Meeting Minutes Transmittal/Approval

Unit Managers Meeting: Grout Treatment Facility
Westinghouse Office, Lacey, Washington
Meeting Held April 23, 1992

Engineering Change Notices (B-714-114, -117, -118, -119, -120, -121 & -122)

Ref. Dwg.
H-2-77582

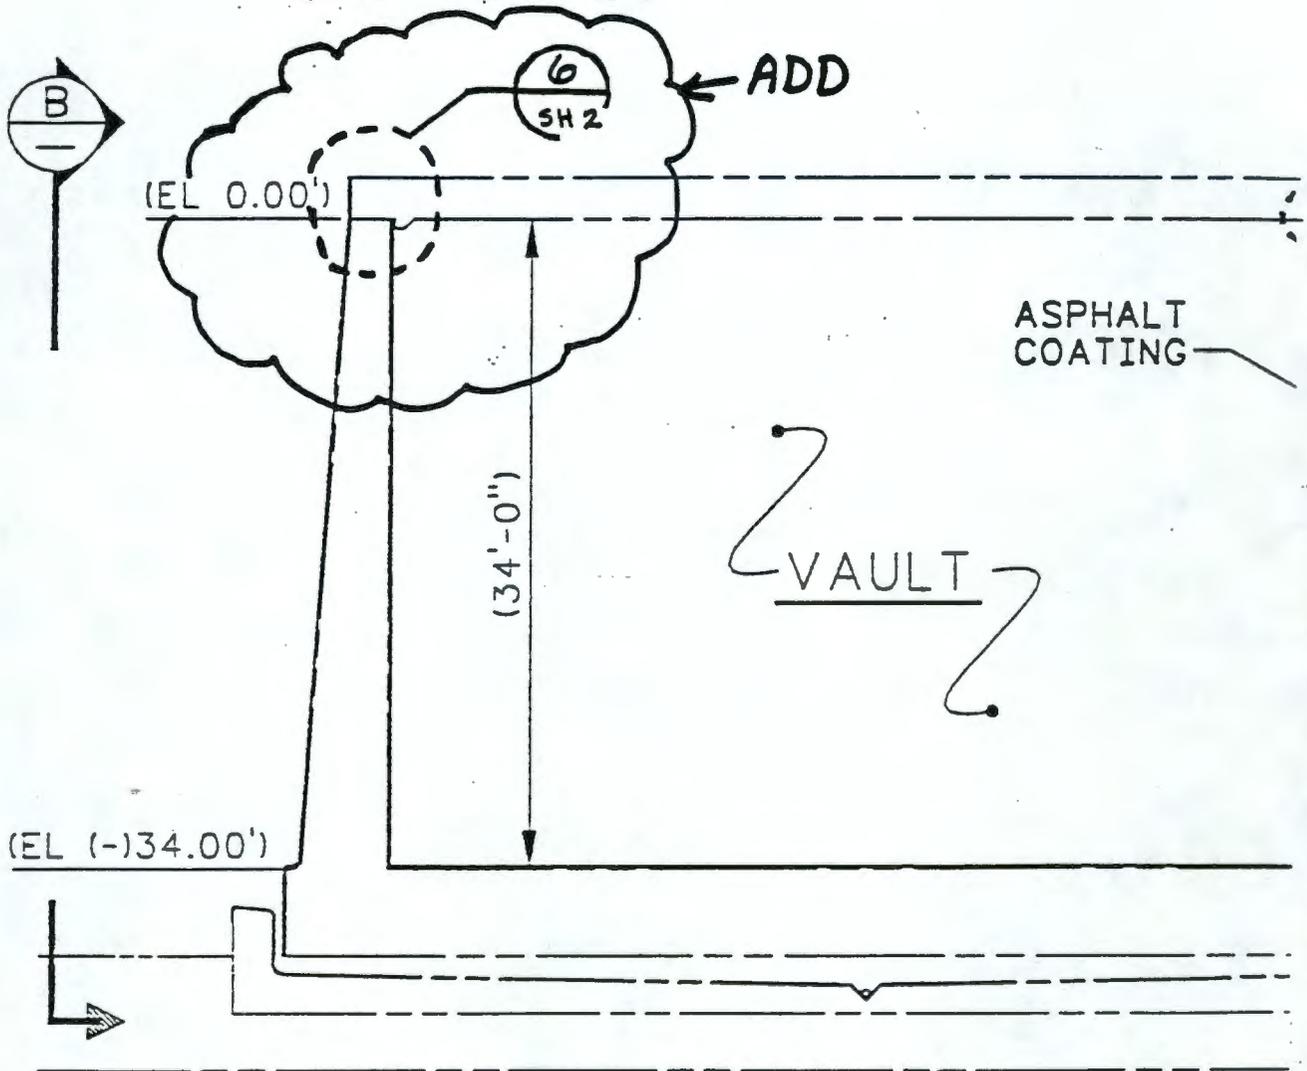
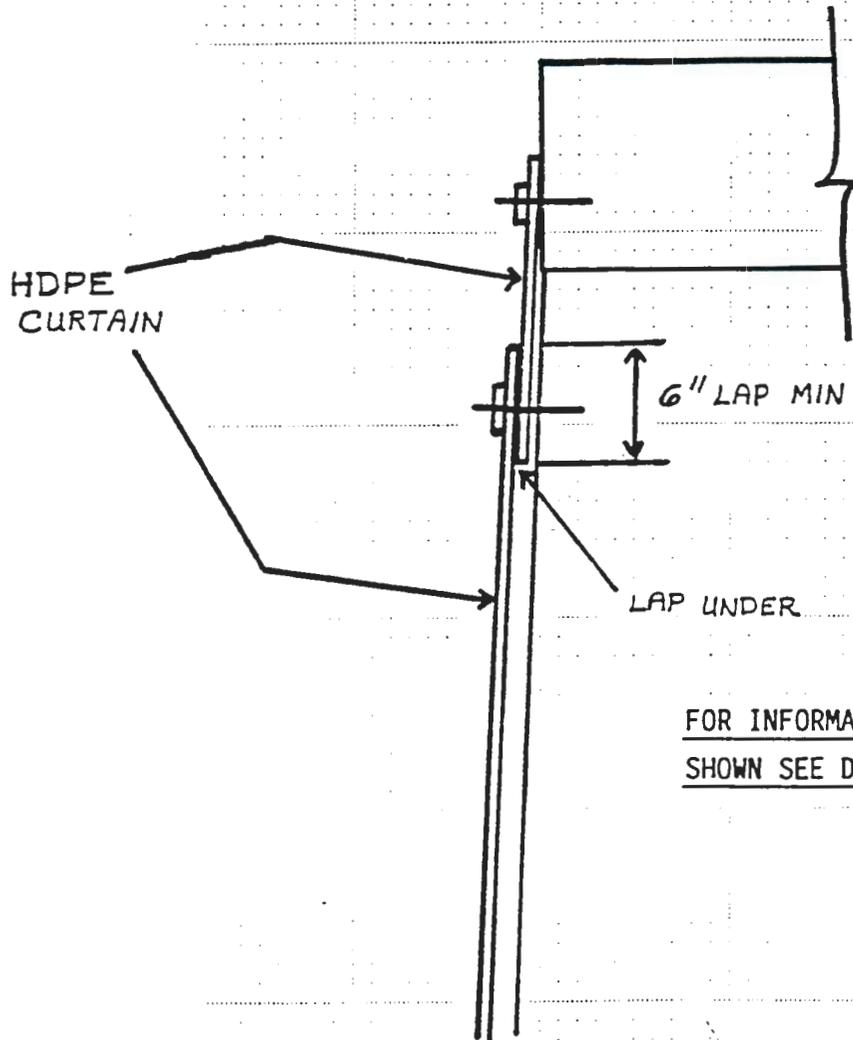
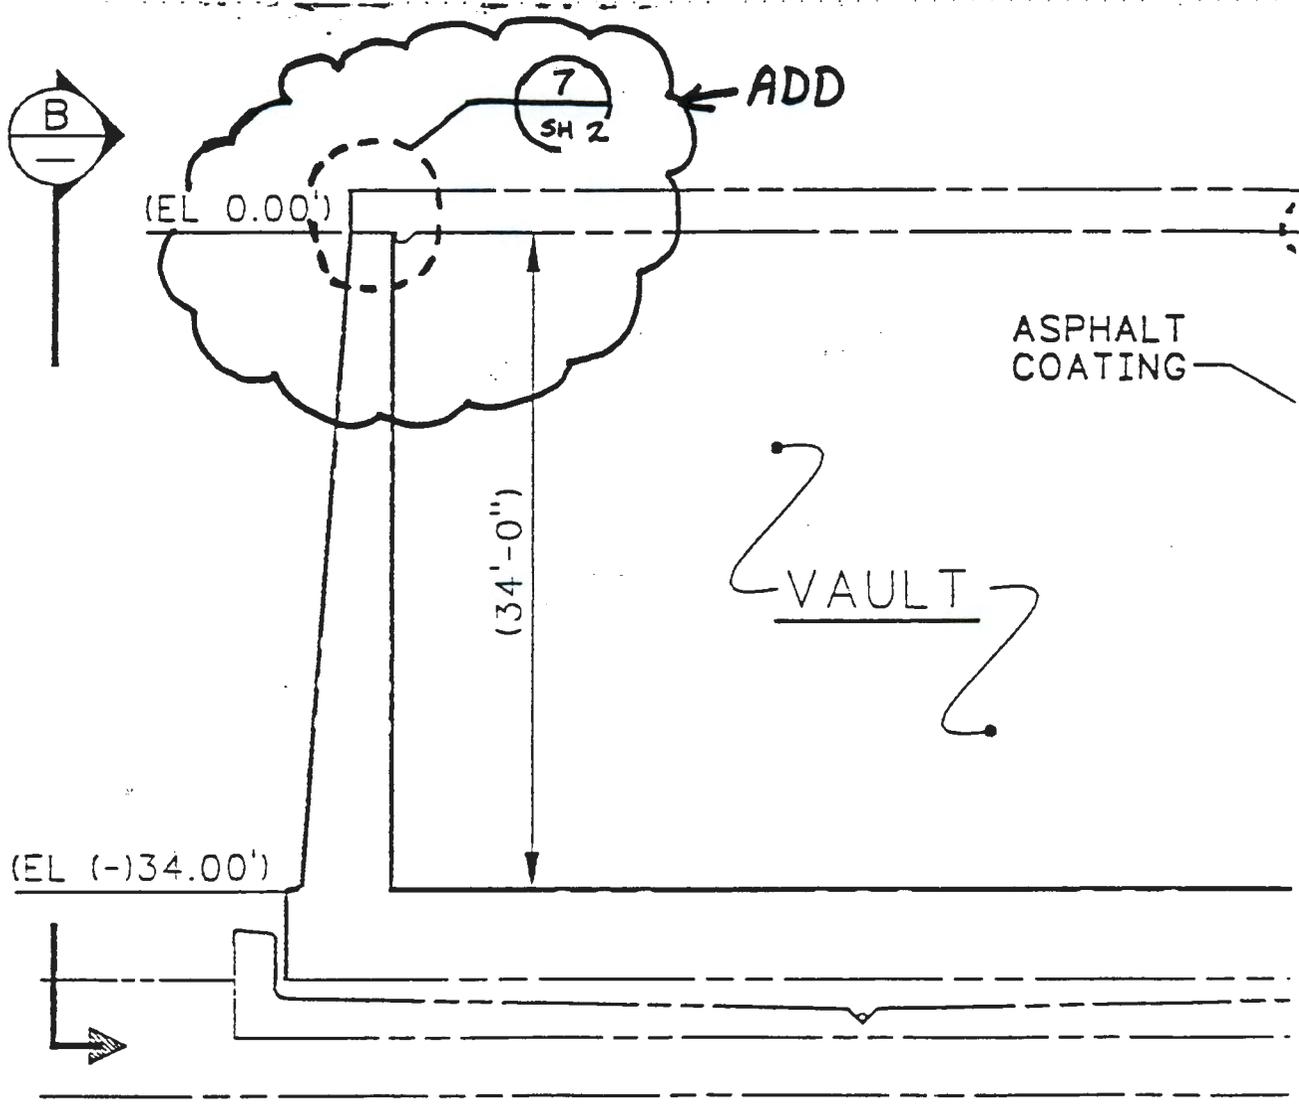
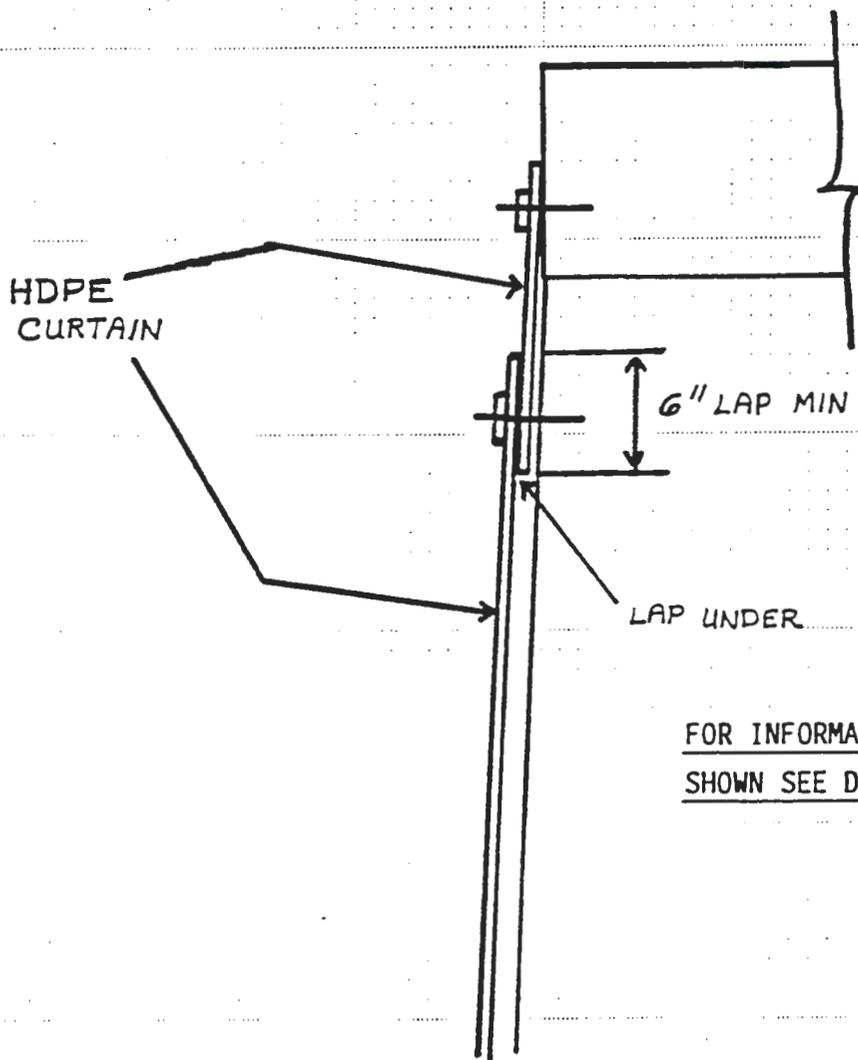
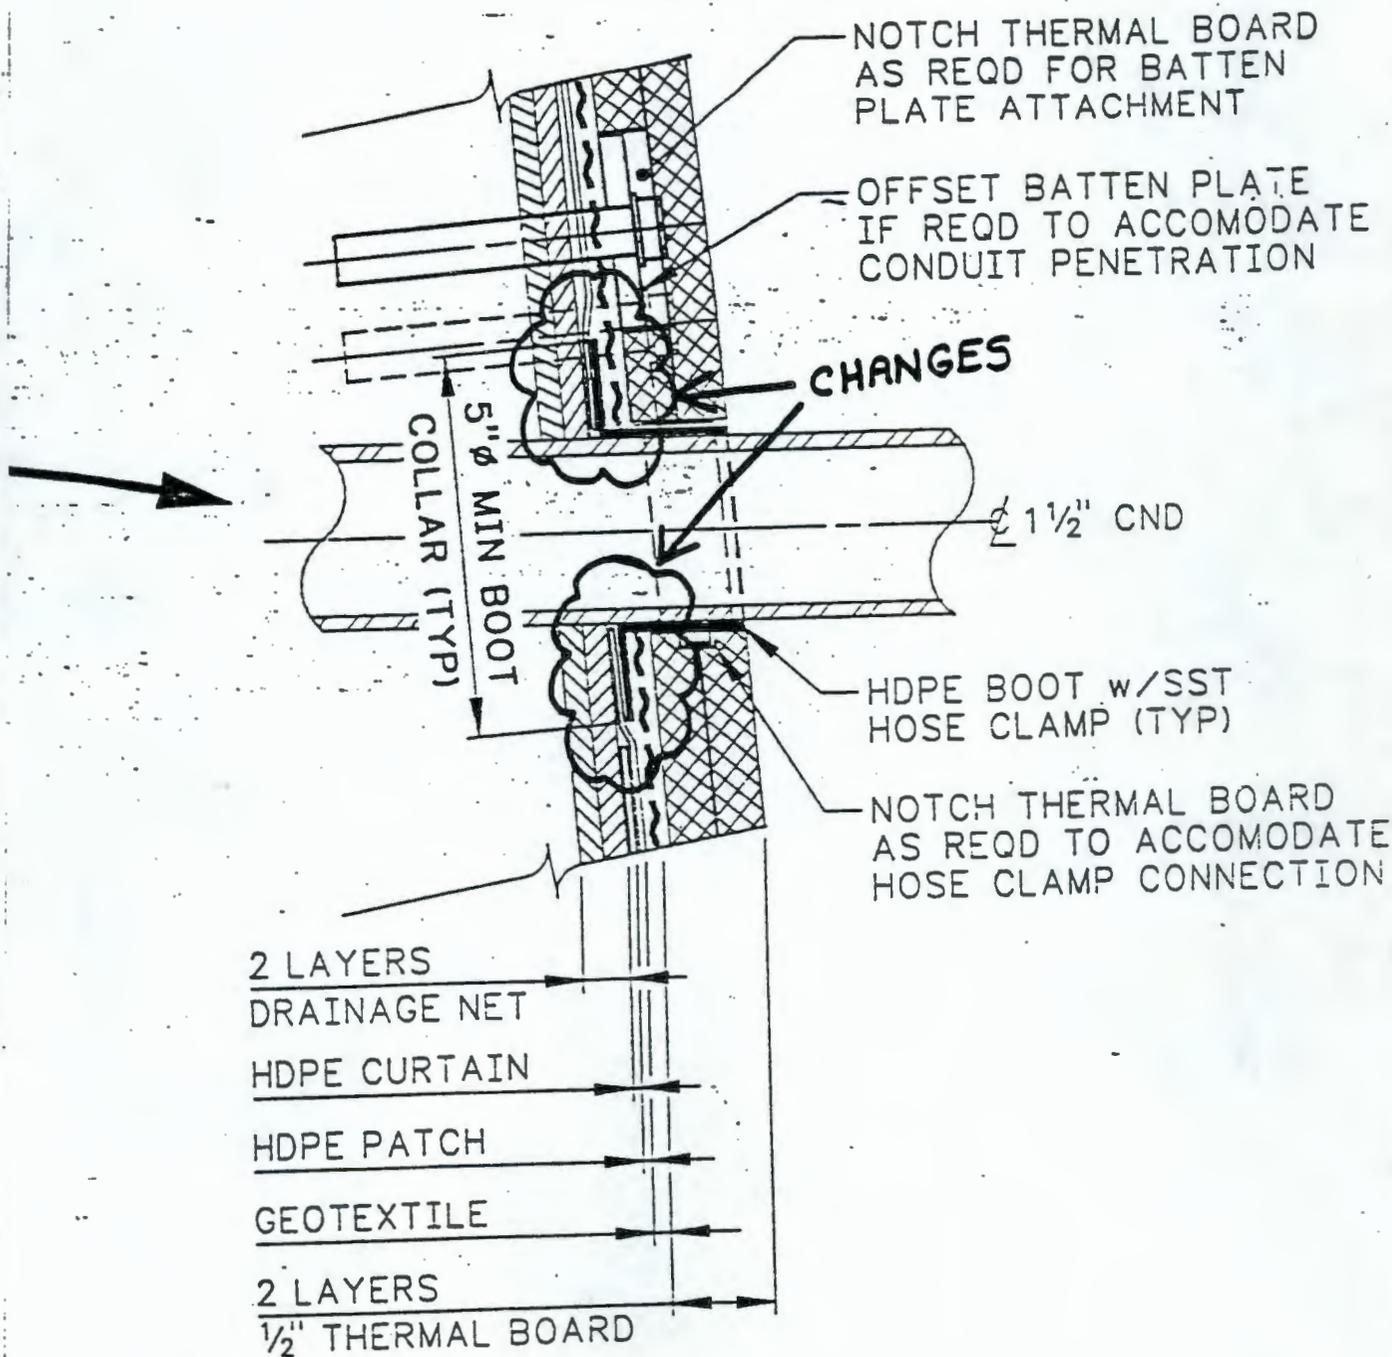
- 1) H-2-77582, Sh 1, Rev 1
Section A (Z F4): Add detail bubble as shown on page 4 of this ECN.
- 2) H-2-77582, Sh 2, Rev 0
 - A) Detail 4 (ZE-F3): Relocate HDPE boot to outside of HDPE patch as shown on page 8 of this ECN.
 - B) Add new Detail 6 as shown on page 5 of this ECN.
- 3) H-2-78451, Sh 1, Rev 1
Section A (Z F4): Add detail bubble as shown on page 6 of this ECN.
- 4) H-2-78451, Sh 2, Rev 0
 - A) Detail 5 (ZE-F3): Relocate HDPE boot to outside of HDPE patch as shown on page 8 of this ECN.
 - B) Add new Detail 7 as shown on page 7 of this ECN.

DETAIL 5
SCALE: NONE

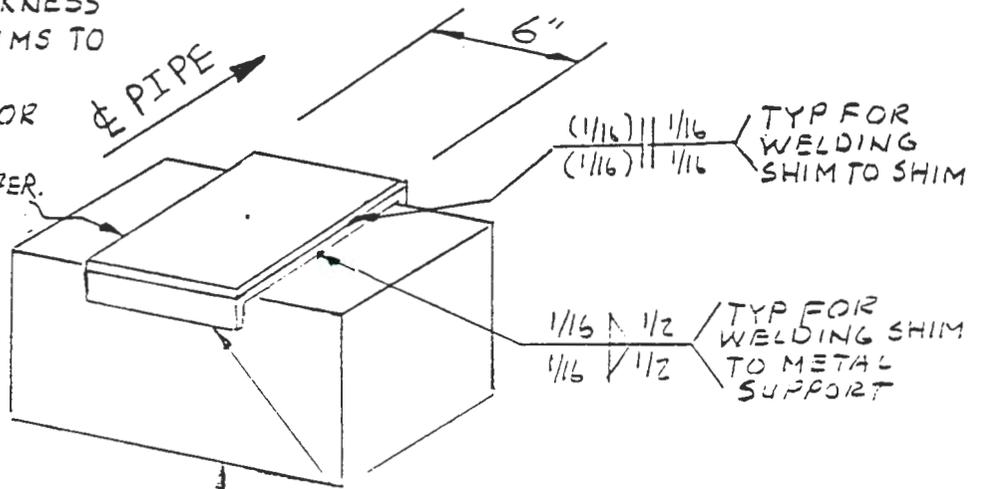
- 2) H-2-77599, Sh 1, Rev 1
- A) Detail 5: Replace old detail with new detail as shown on page 5 of this ECN. (Affects ECN B-714-93, page 1, item 3B).
- B) Detail 6: Add "SEE NOTE 8", shim callouts & overlap dimension as shown on page 6 of this ECN. (Affects ECN B-714-93, page 4).

- 3) H-2-78470, Sh 1, Rev 0
- A) Detail 5: Replace old detail with new detail as shown on page 5 of this ECN. (Affects ECN B-714-93, page 3, item 7B).
- B) Detail 6: Add "SEE NOTE 8", shim callouts & overlap dimension as shown on page 6 of this ECN. (Affects ECN B-714-93, page 4).

NUMBER AND THICKNESS
OF ADDITIONAL SHIMS TO
BE AS REQUIRED.
ASTM A36 PLATE OR
A569 SHEET.
WELD SHIMS TOGETHER.

FIRST SHIM TO BE
ASTM A569 SHEET
10 GA (.1345)
BEND ENDS OF FIRST
SHIM OVER ON CONCRETE
SUPPORTS OR CONCRETE
BLOCKS ONLY

DETAIL 7
SCALE: NONE

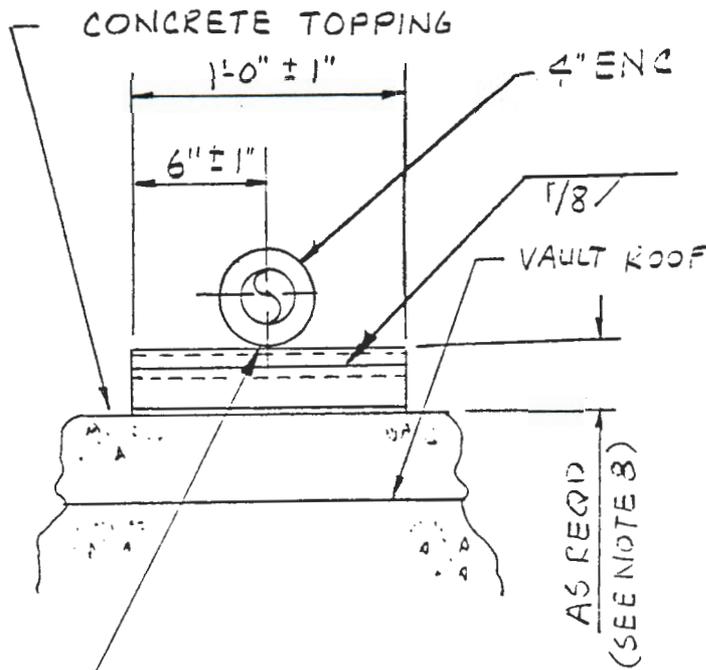
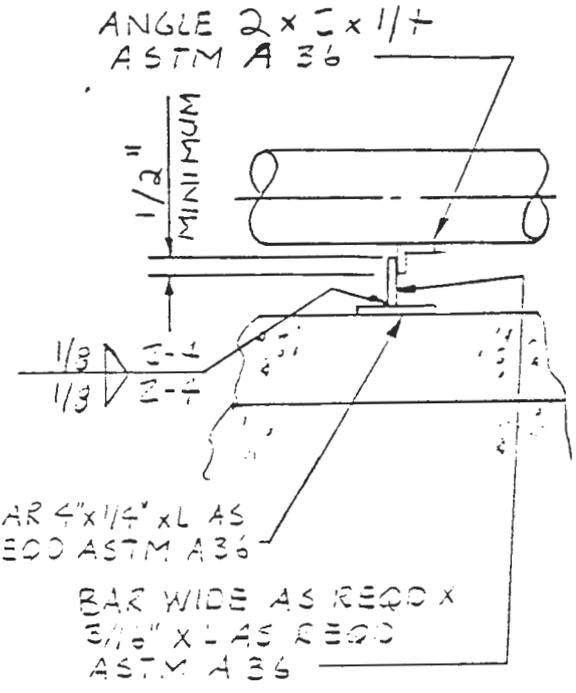
- C) Detail 7: Add new detail as shown on page 7 of this ECN.
- D) Detail 8: Add new detail as shown on page 8 of this ECN.
- E) Notes:
- Change Note 7 to read: CONCRETE BASE SUPPORTS ON SOIL SHALL BE ...

DETAIL - 8
SCALE: NONE
SEE NOTE 9

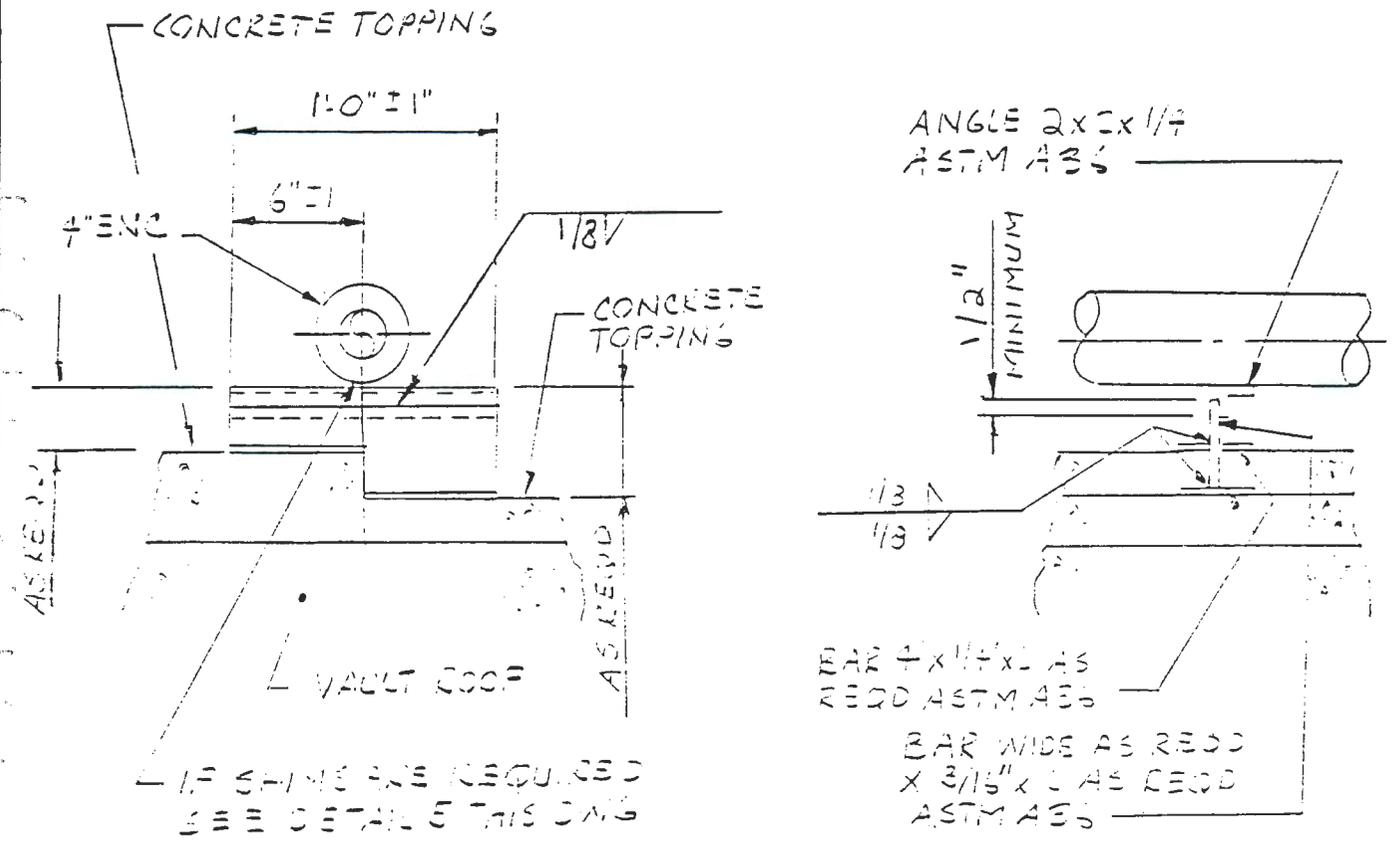
9. USE DETAIL 8 WHERE THE BASE OF A METAL PIPE SUPPORT OVERLAPS ABRUPT ELEVATION CHANGES IN THE TOPPING SLAB.
10. PROVIDE ~~TEMPORARY~~ ^{TEMPORARY} SUPPORT AS REQUIRED TO POSITION PIPE SUPPORT PRIOR TO AND DURING PLACING DIFFUSION MATERIAL.
